STRUCTURE OF THE REDONDO CREEK AREA,
BACA PROJECT, NEW MEXICO: IMPLICATIONS
CONCERNING THE NATURE OF PERMEABILITY/PRODUCTION
AND RECOMMENDATIONS FOR FUTURE DRILLING

FIGURE 6.. Cross Section through Baca 16;
A-A' on Figure 1.

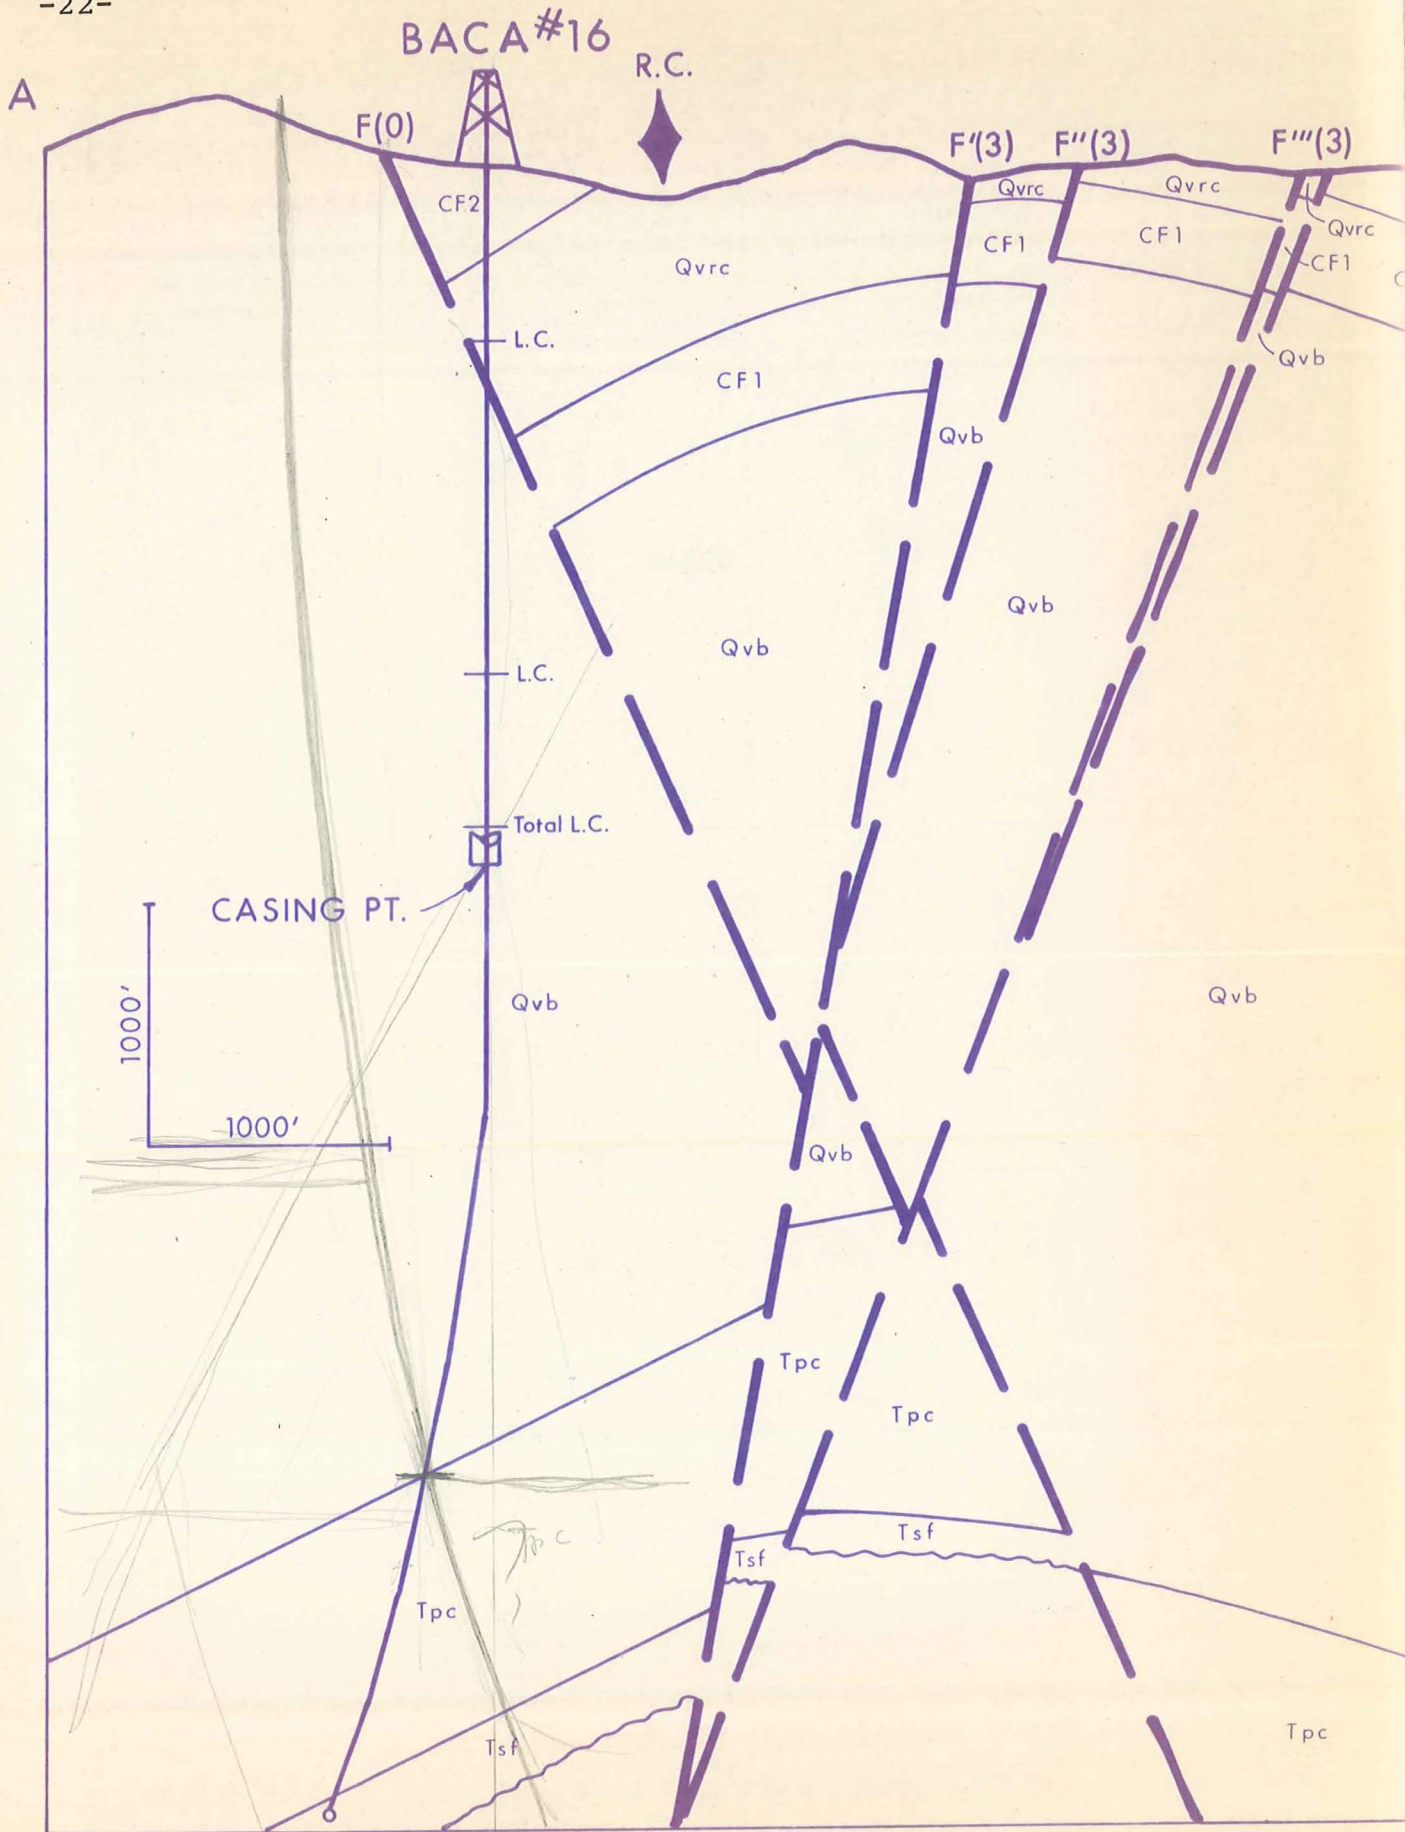
with the well course. The remaining lost circulation zones in the Bandelier Tuff probably correspond to areas characterized by a high density of cooling joints. Despite the presence of lost circulation below the casing point, this well did not produce. We interpret the lack of productivity in Baca 16 to the absence of steeply-dipping faults intersecting the well trend below the casing point. The high temperatures recorded in Baca 16 indicate that additional wells should be drilled in this area but targeted towards the intersection of F(0) with the base of the Bandelier Tuff.

4. Baca 16. The high temperatures encountered in Baca 16 and the presence of adjacent steeply-dipping structures suggest that a redrill of this well is warranted. F(0) was crossed at a very shallow level, but this fault could be penetrated again or even F(3) could be intersected if Baca 16 were plugged to ~ 7500 ft. (elevation) and the redrill targeted to the southeast at a 30° deviation from vertical (Figure 6).
